REPORT

SUBJECT: **Appeals Docket 2017-06**

Variance to allow construction of a house.

Address: 6867 Windsor Road
District: 3-Outer Village Residential Neighborhood
Applicant: Lewis Land Professionals, Joseph Burgoon
Don and Ann Michele Tharp
Owner: Ann Michele Tharp

Exhibit G

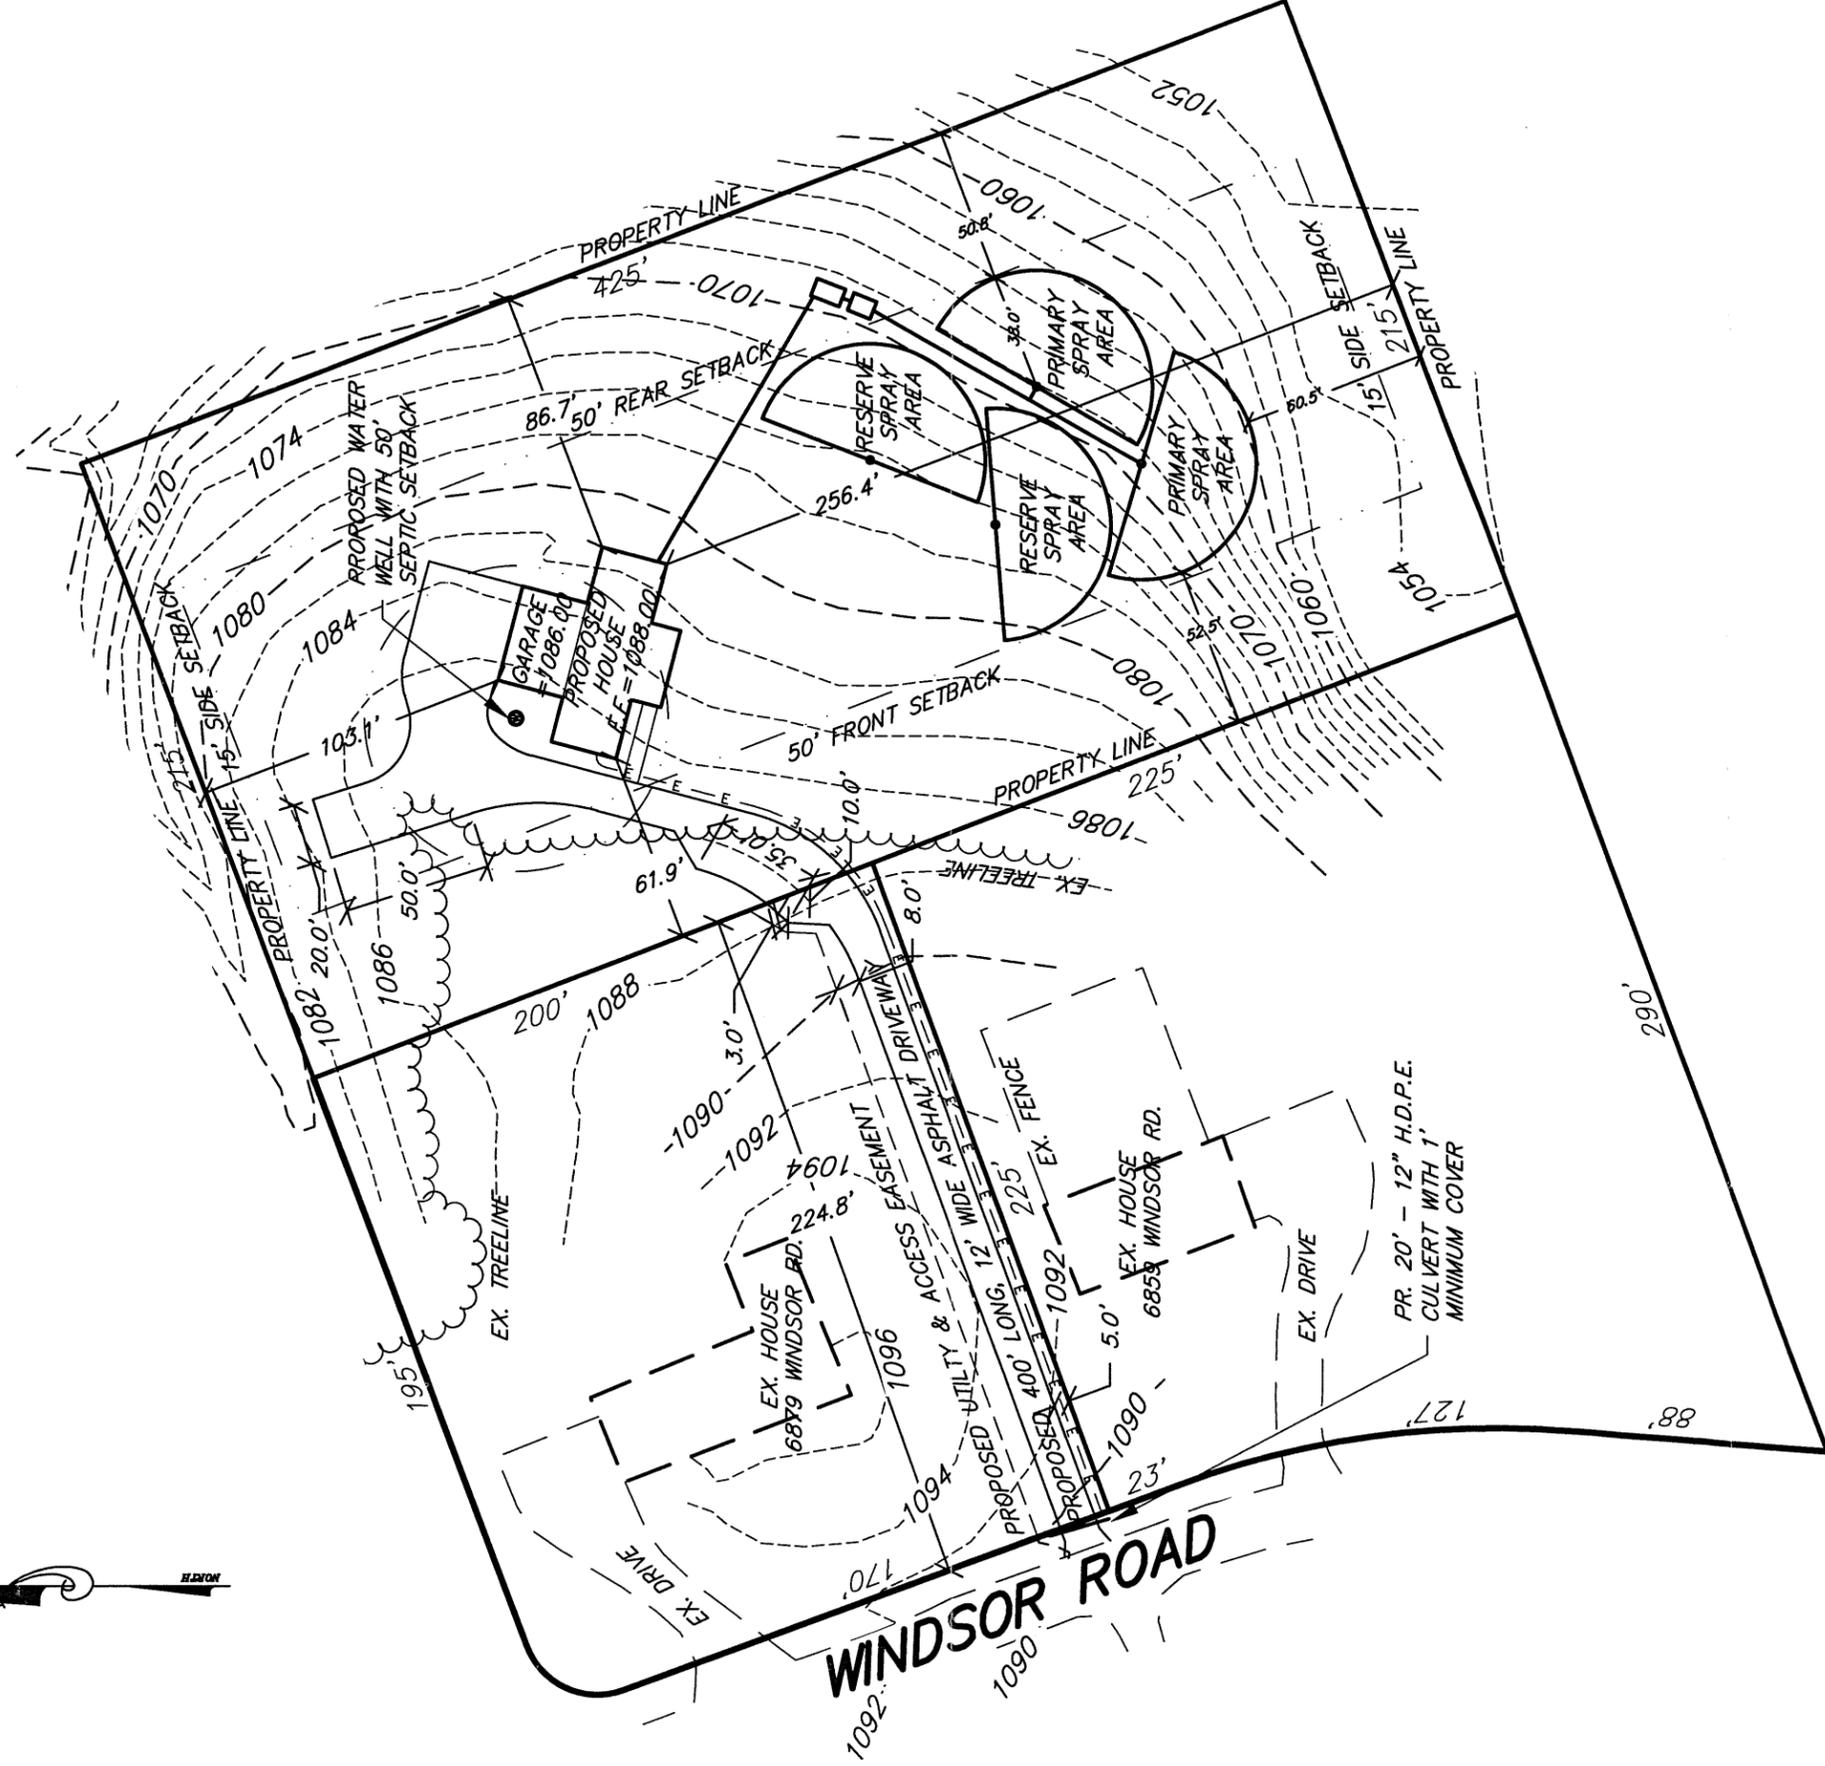
Identify compliant surface material for driveway.
2. **Driveway Width:** 1207.13(c)(9)(J)(iv)
 - Twelve feet is the minimum acceptable width. An additional three foot strip on each side of the driveway is to be kept clear of trees and bushes. (This would permit easier deployment of fire hoses and equipment).

Identify 3 foot working clearance on each side of 12 foot driveway.
3. **Vertical Clearance:** 1207.13(c)(9)(J)(xii)
 - A minimum unobstructed clearance of 13 feet 6 inches is needed, and must be maintained year round.

Identify 13' 6" overhead clearance along driveway
4. **Driveway Length:** 1207.13(c)(9)(J)(ix)
 - All new residential driveways shall not exceed 600 feet in length unless connected to a second approved public access point.
5. **Grade:** 1207.13(c)(9)(J)(xiii)
 - The maximum grade of any residential driveway that also acts as a fire access drive shall be 4%.
6. **Load Capacity:** 1207.13(c)(9)(J)(viii)
 - 50,000 pounds is the minimum acceptable weight bearing capacity needed for these driveways.
(This is determined by the weight of the fire apparatus typically used for residential structural firefighting)

Provide design professional statement of weight bearing capacity.
7. **Bridges and Culverts:** HFD Requirement
 - All bridges and culverts must meet the minimum weight bearing capacity of 50,000 pounds.
 - All bridges shall be clearly posted with the weight bearing capacity.
 - All bridges and culverts must meet the minimum width requirement of 12 feet.

Confirm no bridges or culverts or provide design professional statement of weight bearing capacity.
8. **Driveway Turnouts:** (1207.13(c)(9)(J)(iv))
 - All new driveways exceeding 300 feet in length shall have a vehicle turnout located every 200 feet.

Confirm compliance with access easement requirement.

Per your request I have reviewed 01/10/17 revision of the "Lot Fit Sketch" for the proposed residence at 6867 Windsor Road. I have made my comments on the attached *Residential Fire Access Driveway Requirements* document. Typically we provide this document to applicants as a design resource prior to submittal for review. The intent of this resource is to facilitate an efficient design, approval and construction process. Because we were unable to connect after several telephone messages, I made my comments on the attachment.

- DRIVEWAY NOTES:
1. DRIVEWAY HAS BEEN DESIGNED TO SUPPORT MORE THAN 50,000 POUNDS OF BEARING CAPACITY. SEE DRIVEWAY CERTIFICATION LETTER FOR THIS PROPERTY.
 2. AN ADDITIONAL 3" STRIP ON EACH SIDE OF THE DRIVEWAY IS TO BE KEPT CLEAR OF TREES AND BUSHES.
 3. A MINIMUM UNOBSTRUCTED OVERHEAD CLEARANCE OF 13'6" FOR THE DRIVEWAY IS REQUIRED TO BE MAINTAINED YEAR ROUND.
 4. THE ENTIRE DRIVEWAY MUST BE KEPT CLEAR OF SNOW AND ICE BUILD-UP DURING THE WINTER SEASON.
 5. MAXIMUM SLOPE OF THE DRIVEWAY SHALL BE 4%.
 6. IT IS THE RESPONSIBILITY OF THE GRANTEE OF THE UTILITY & ACCESS EASEMENT TO MAINTAIN THE CONDITION OF VEGETATION, PAVEMENT, & OTHER IMPROVEMENTS INSIDE OF THE EASEMENT.

I have reviewed the revised submittal for the proposed residence at 6867 Windsor Road. Upon review I find that all previous comments have been addressed. I also understand that you are working with Kris McMaster to address the easement.

Thank you for putting together this letter. I have revised the plan for the proposed driveway and easement to incorporate the access requirements. Notes have been added to the plan to call out some of the requirements which are not depicted on the plan view.

AUTOTURN PLAN

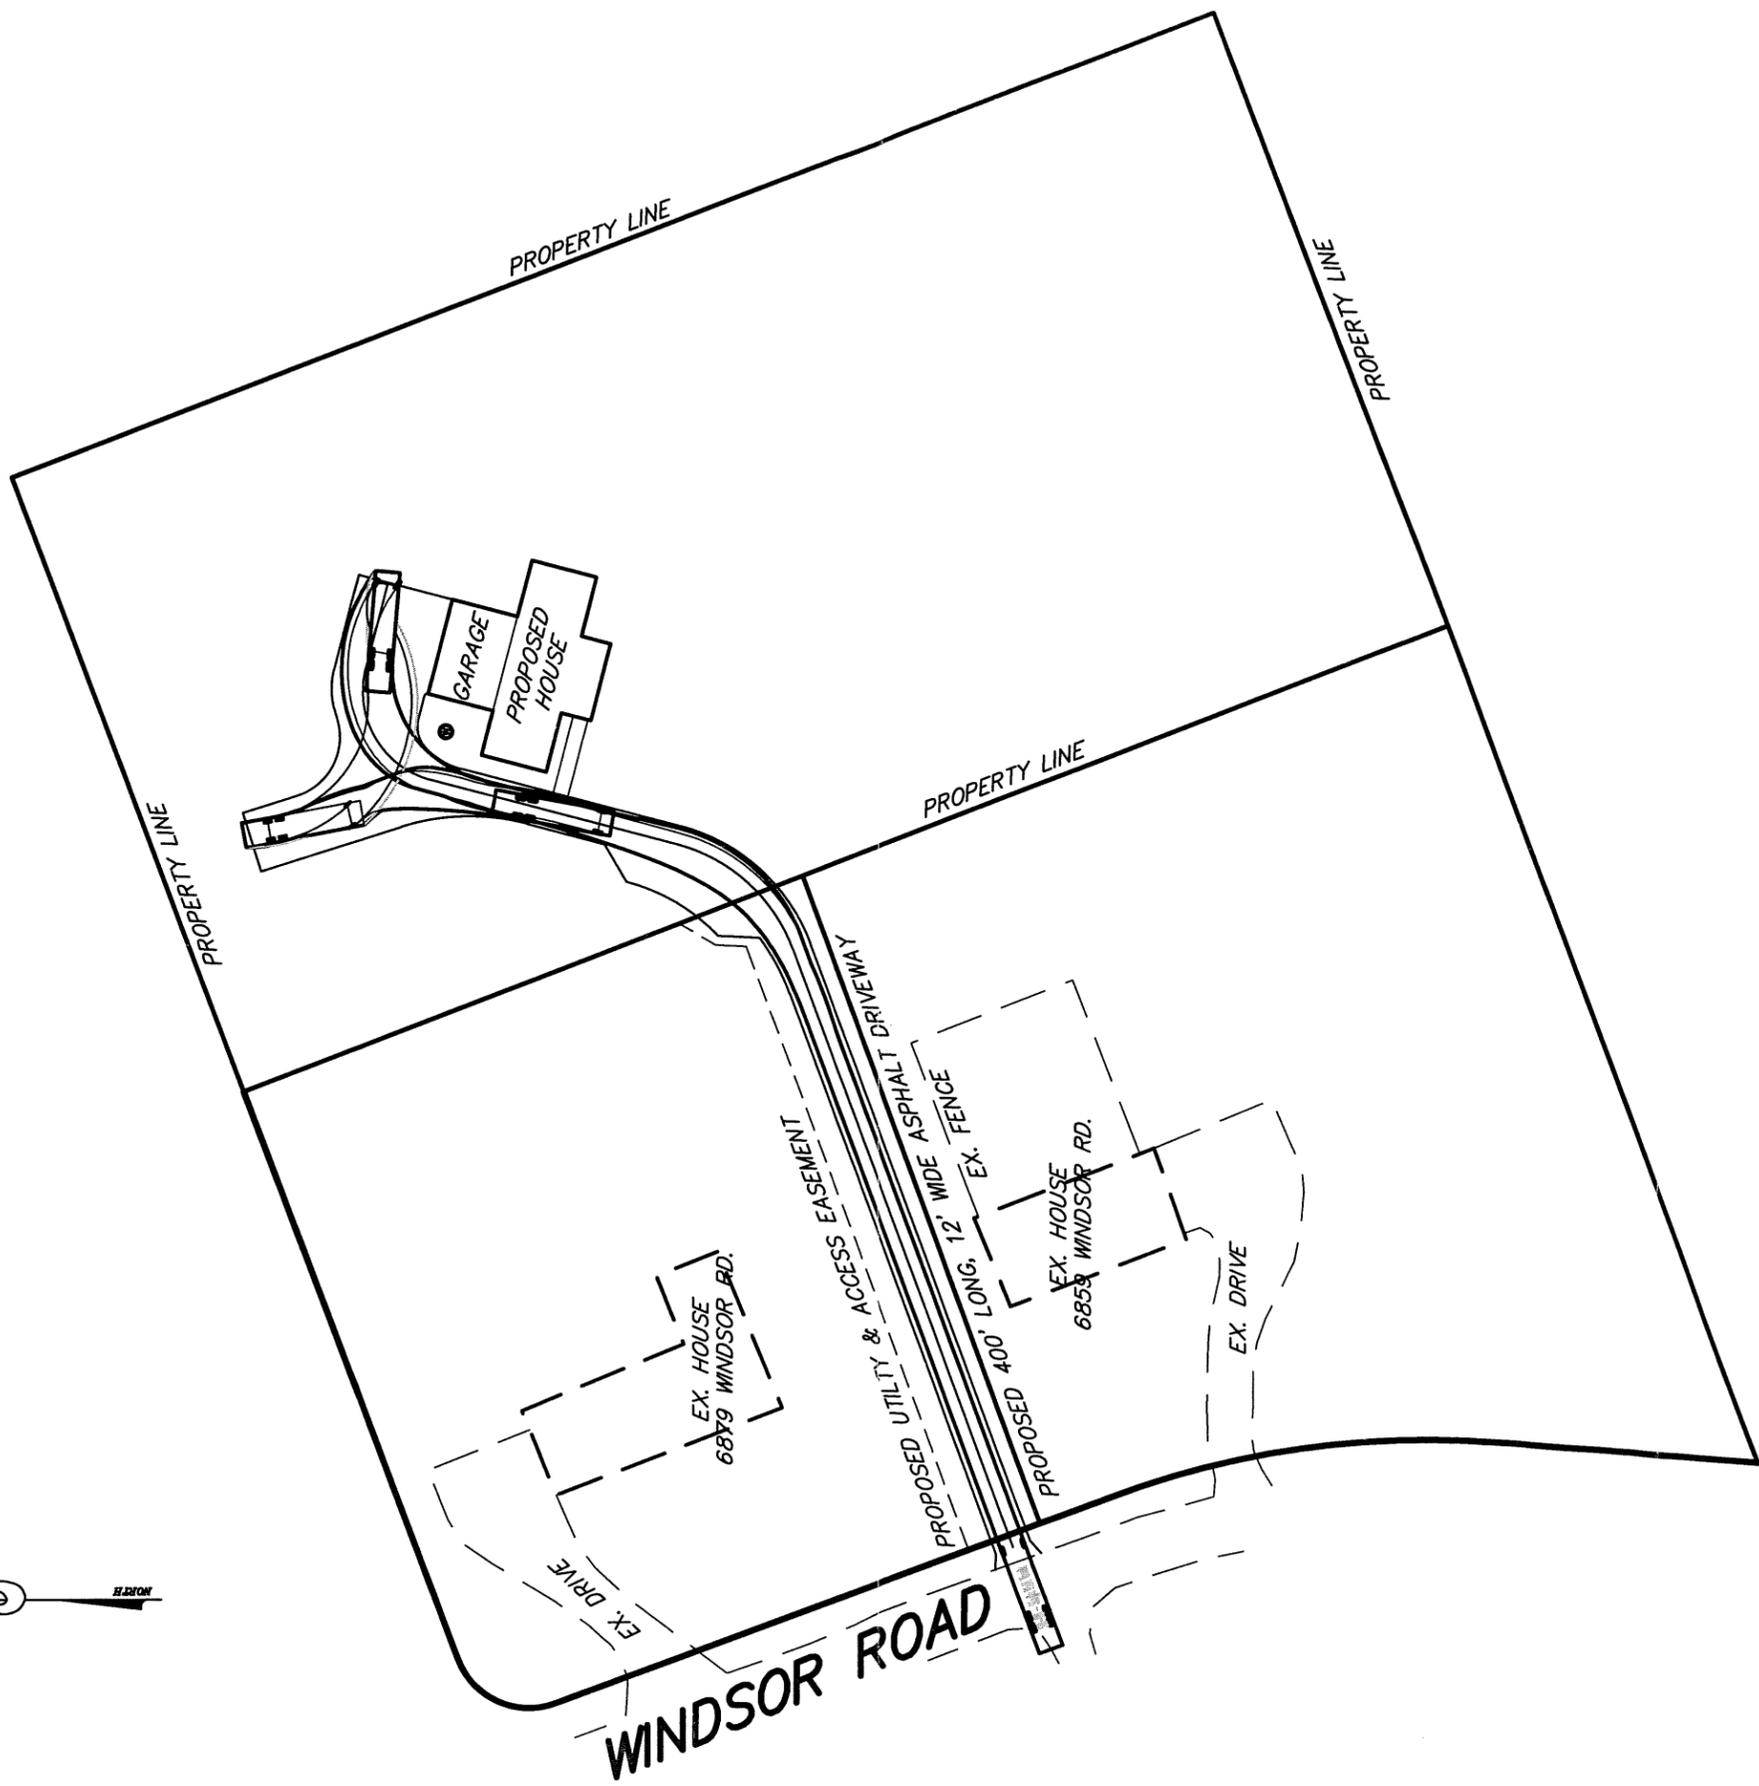
Please let me know if this plan now complies with all of the requirements for Hudson Fire Department. Based on #9 of the requirements, it says that our alternative turnaround requires specific approval.

A program called AutoTurn was used to analyze the ability of a fire truck to turn around in the driveway provided for the proposed house. The turnaround area was designed to allow a 42' long fire truck to drive in, back up, and drive out. A turnout is also provided along the length of the driveway. The AutoTurn Plan is attached as Exhibit H.

I have attached a driveway certification letter which describes the thickness of the proposed asphalt pavement for the driveway, and a plan showing the maneuverability of the driveway for a fire truck to go in, turn around, and exit. We use a program called AutoTurn to model the turning radius of fire trucks as shown on the plan.
